18920 SMITH RD – OUTDOOR STORAGE SITE PLAN

LOT 1, BLOCK 1 OF F.L. RED GRANT CONSTRUCTION COMPANY SUBDIVISION FILING No. 1

CITY OF AURORA, ADAMS COUNTY, COLORADO

COVER SHEET
18920 SMITH ROAD
AURORA, CO

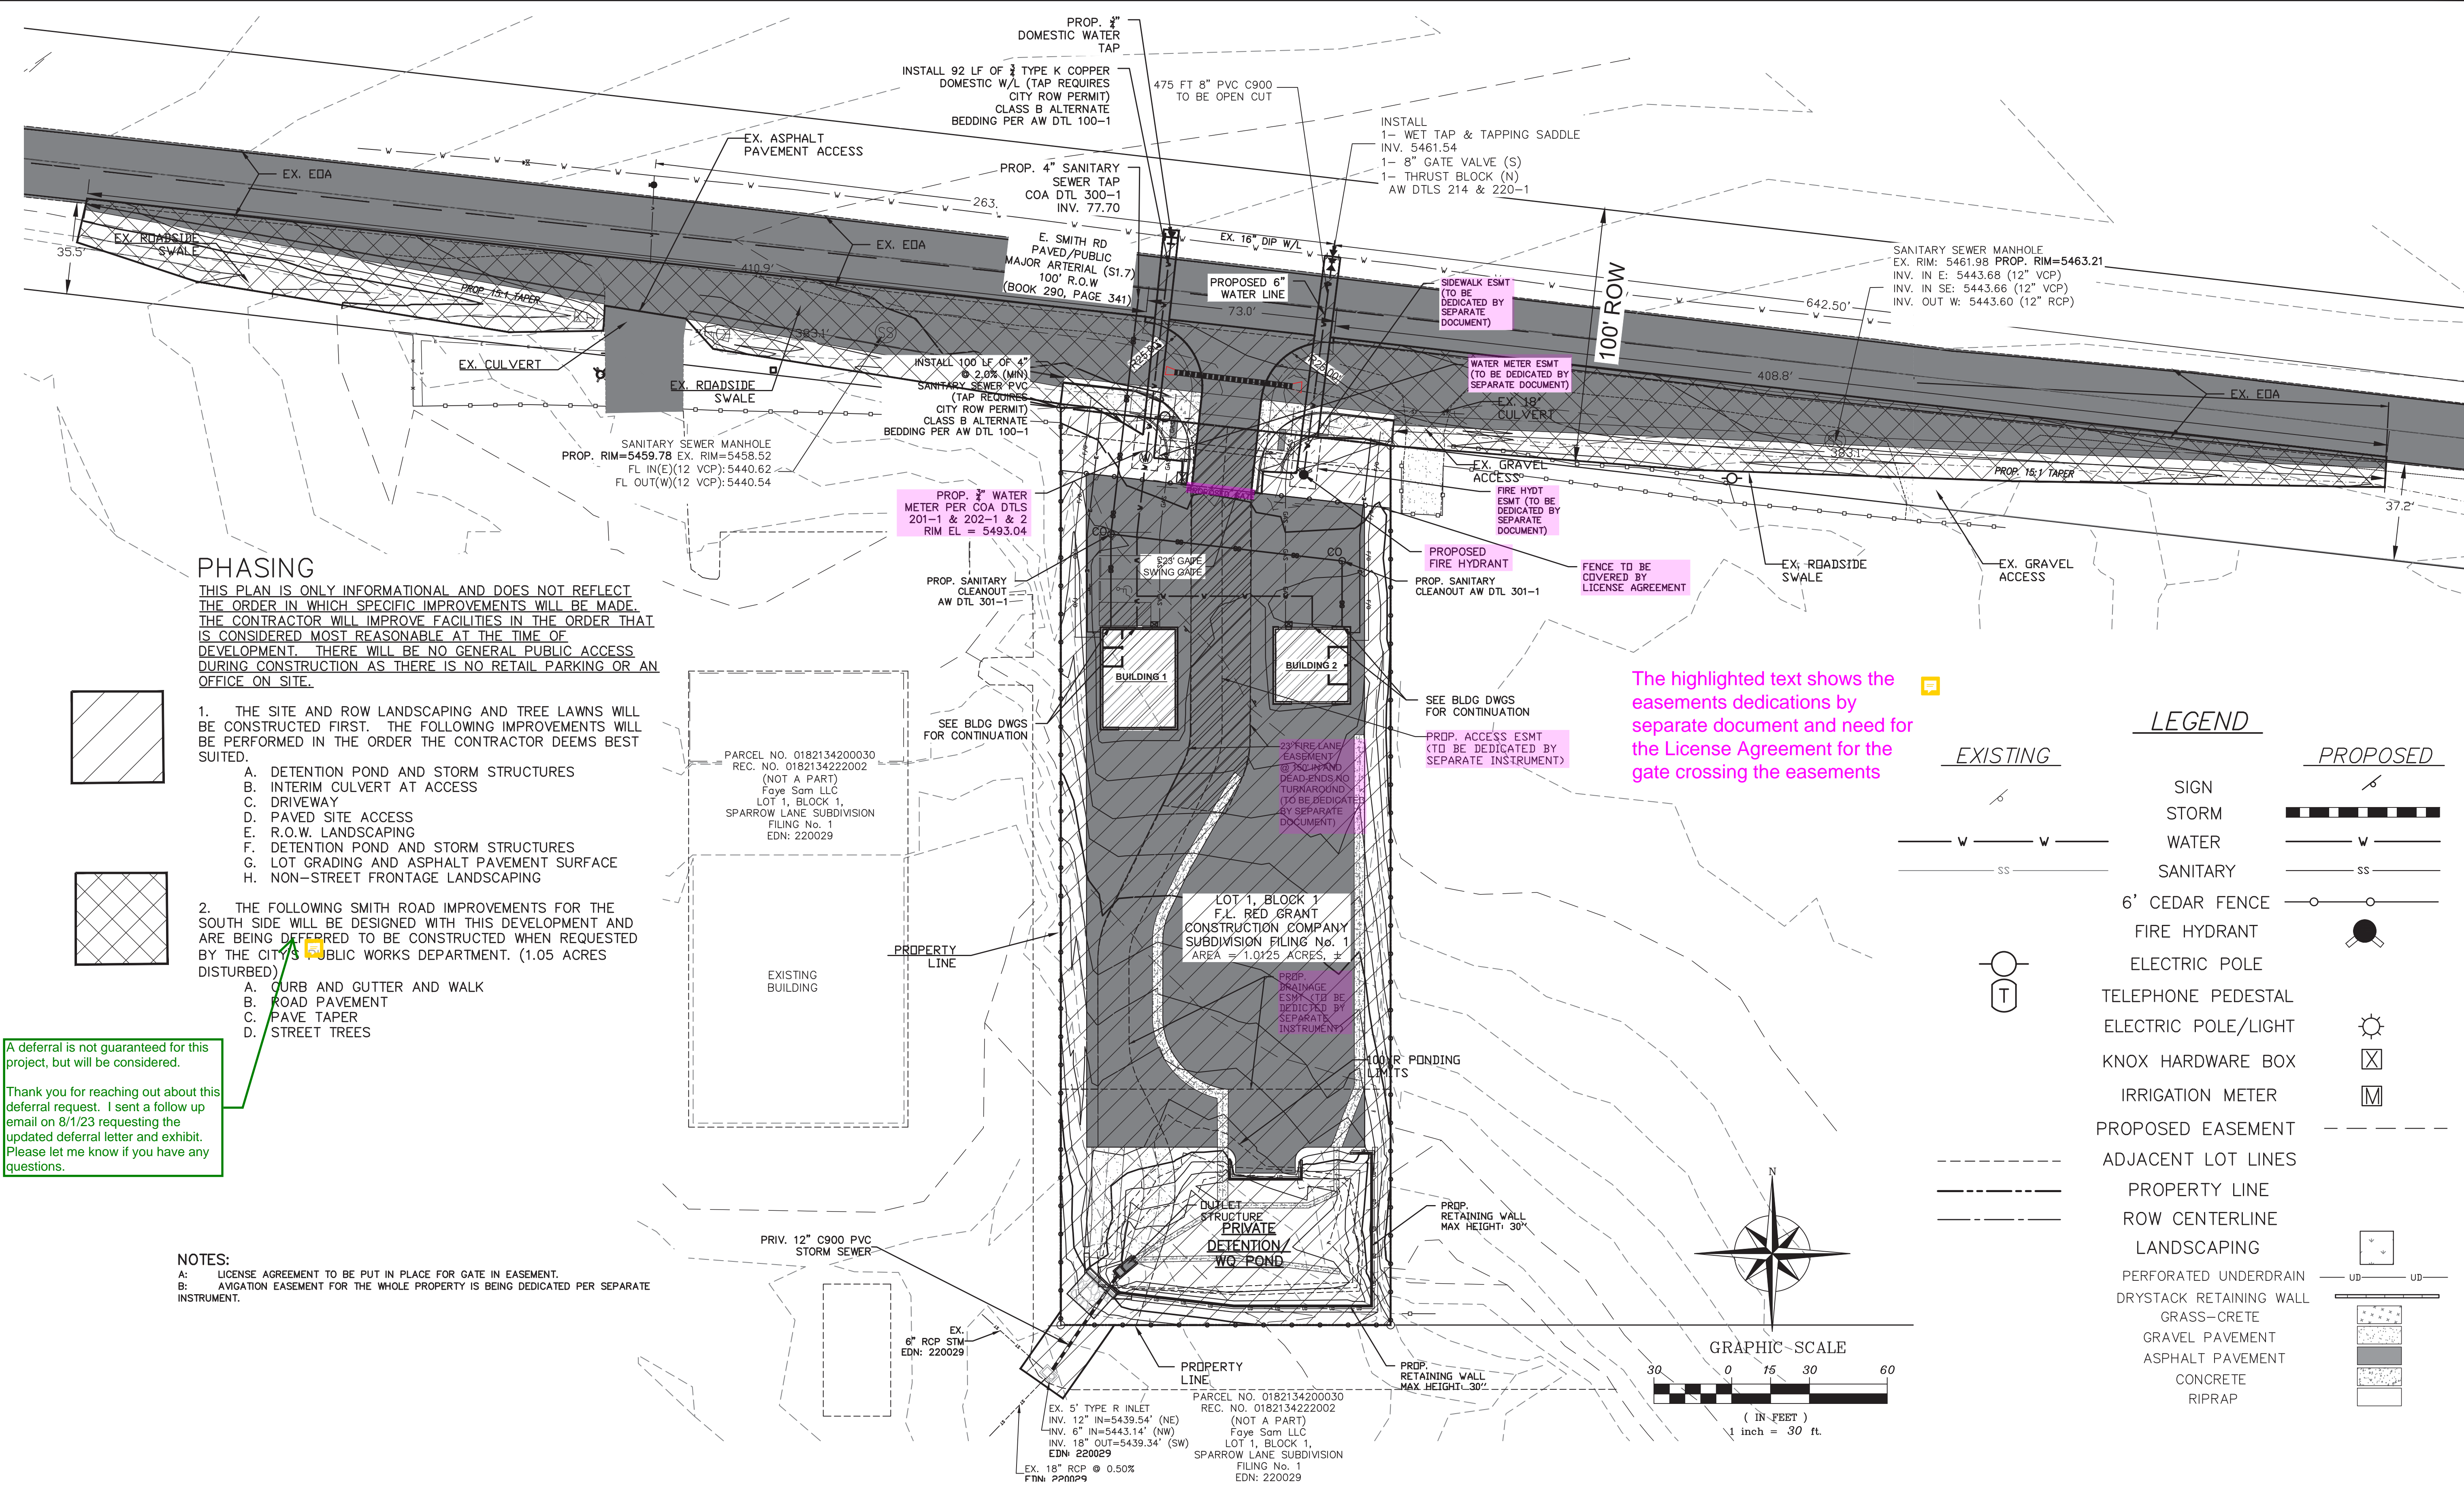
Deferral letter originally submitted and exhibit are still outstanding. Comments for the deferral letter were sent back on 8/1/23. Please also be sure to update the deferral agreement exhibit with the extents shown in this site plan.

Repeat comment:

The site plan will not be approved by public works until the preliminary/master drainage study is approved

18920 SMITH RD - OUTDOOR STORAGE	DATE	07/24/23	PHASING PLAN 18920 SMITH ROAD AURORA, CO	SHEET NO 2 OF 10
	CAD NO	8591BASE		
	JOB NO	859-1		
	DATE	07/24/23		
Rocky Ridge Civil Engineering 420 21st Ave, Suite 101 Longmont, CO 80501 303.651.6626 http://rockyridgecivil.com

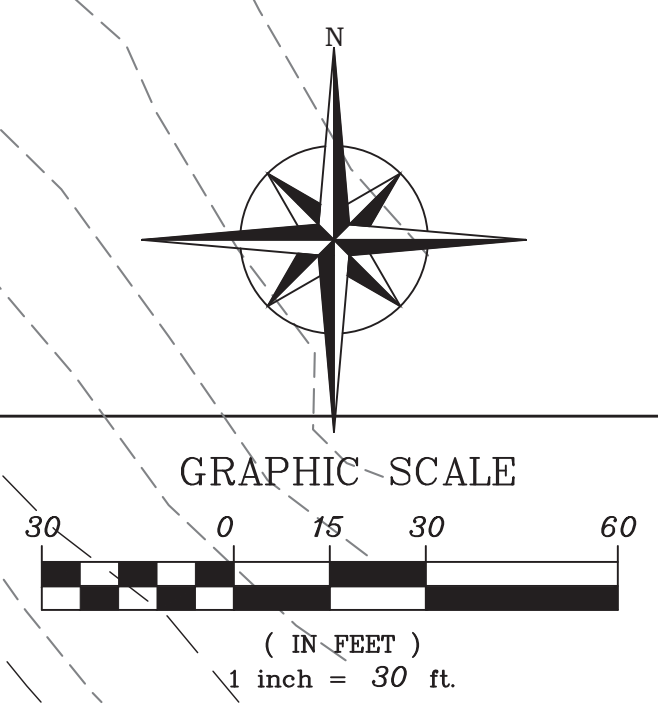
A deferral is not guaranteed for this project, but will be considered.

Thank you for reaching out about this deferral request. I sent a follow up email on 8/1/23 requesting the updated deferral letter and exhibit. Please let me know if you have any questions.

The highlighted text shows the easements dedications by separate document and need for the License Agreement for the gate crossing the easements

18920 SMITH RD - OUTDOOR STORAGE		JOB NO 859-1
SITE PLAN SHEET 18920 SMITH ROAD AURORA, CO	DATE 07/24/23	CAD NO 8591BASE

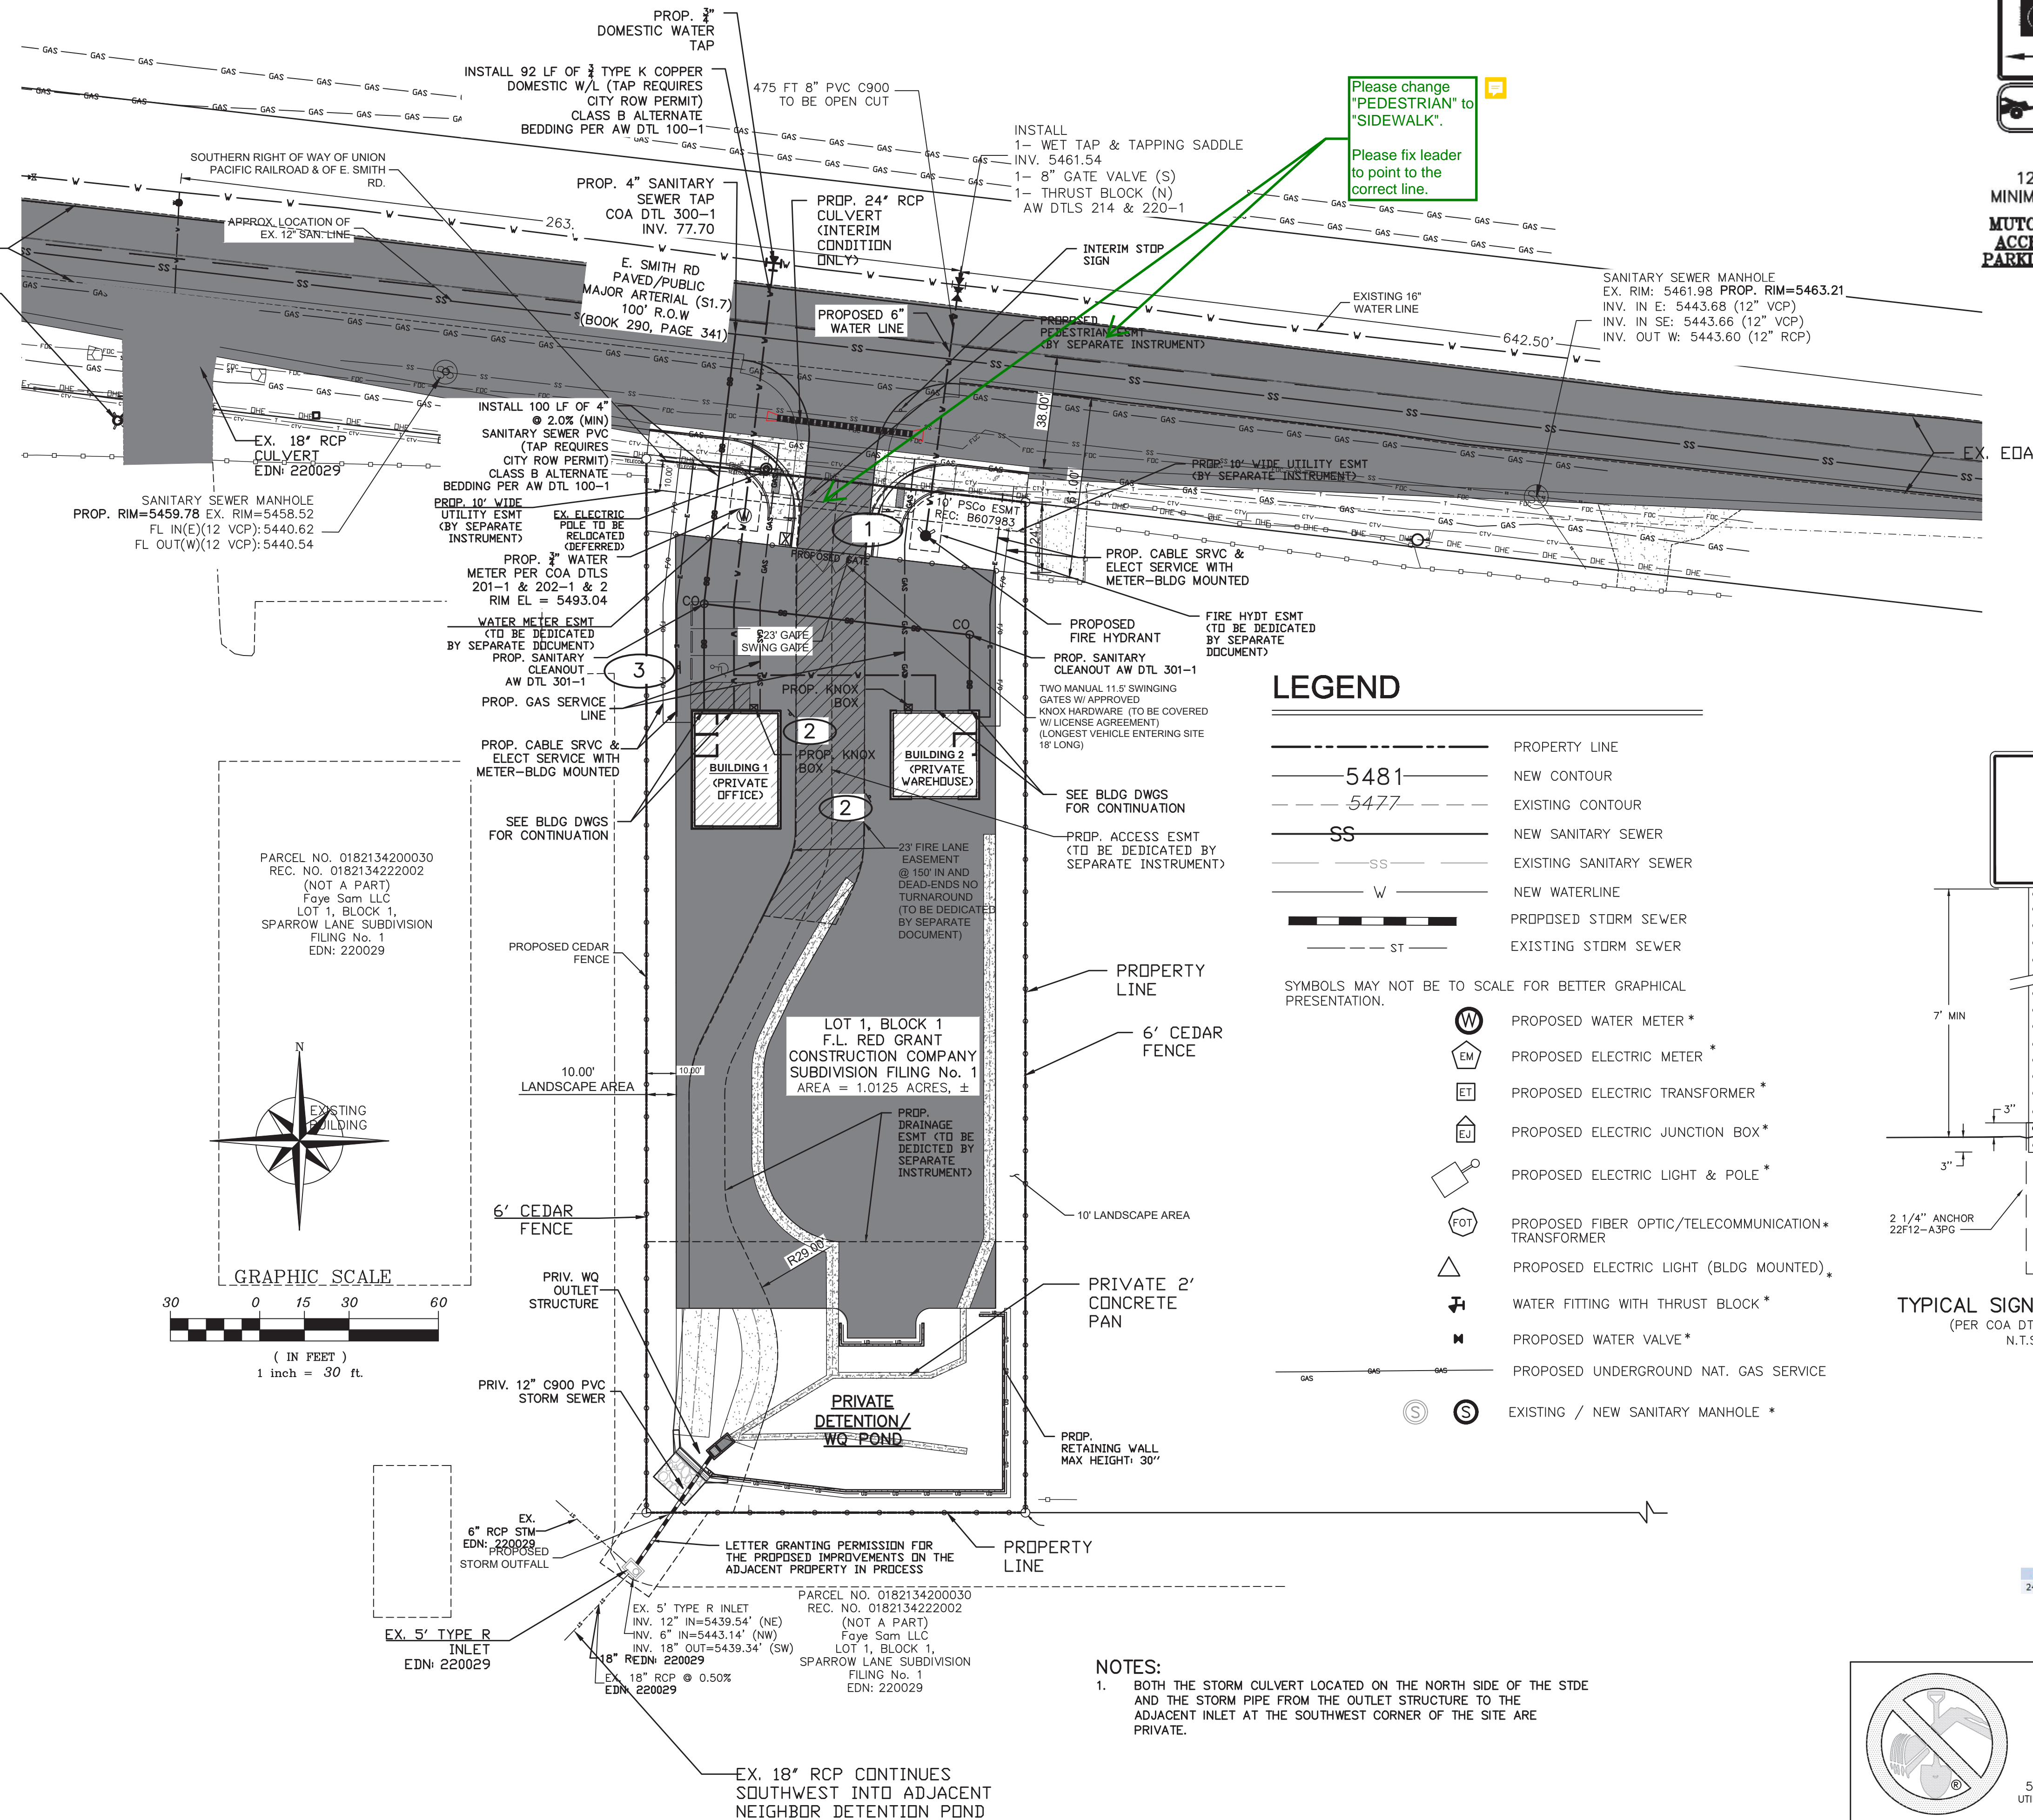
A deferral is not guaranteed for this project, but will be considered.

Thank you for reaching out about this deferral request. I sent a follow up email on 8/1/23 requesting the updated deferral letter and exhibit. Please let me know if you have any questions.
